Ref. No. 201706014 Petition No. 1402

REQUEST ENCROACHMENT
A PORTION OF DEQUINDRE CUT
VARIOUS WIDTHS IN THE AREA BOUND BY
DIVISION, ORLEANS, BREWSTER ST.
AND ST. AUBIN AVE.
(With Temporary Storage Containers)

CIT	Y OF DETROIT	
CITY ENGINEERING DEPARTMENT		
;	SURVEY BUREAU	
JOB NO.	01-01	
DRWG. NO.	X 1402

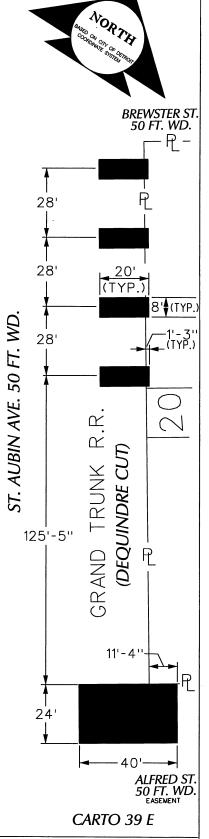
- (X) Involved; have no objection to the request to encroach a portion of Dequindre Cut various widths in the area bound by Division, Orleans, Brewster St. and St. Aubin Ave. (with temporary storage containers) as shown on drawing no. x1402 dated 06-16-2017 provided that the following conditions are met:

- The area requested for encroachment shall be in City's right of way (not under the Railroad right-of way.)
  - The petitioner shall seek approval from City Engineering Division of DPW for pavement/access route to be used by all service vehicles/equipment such as construction vehicles, food trucks, etc. to ascertain that the pavement is capable of supporting them.

- Any damage caused to the pavement or other infrastructure resulting from construction, loading/unloading activities shall be the responsibility of the petitioner and shall be repaired by the petitioner at no cost to the City.
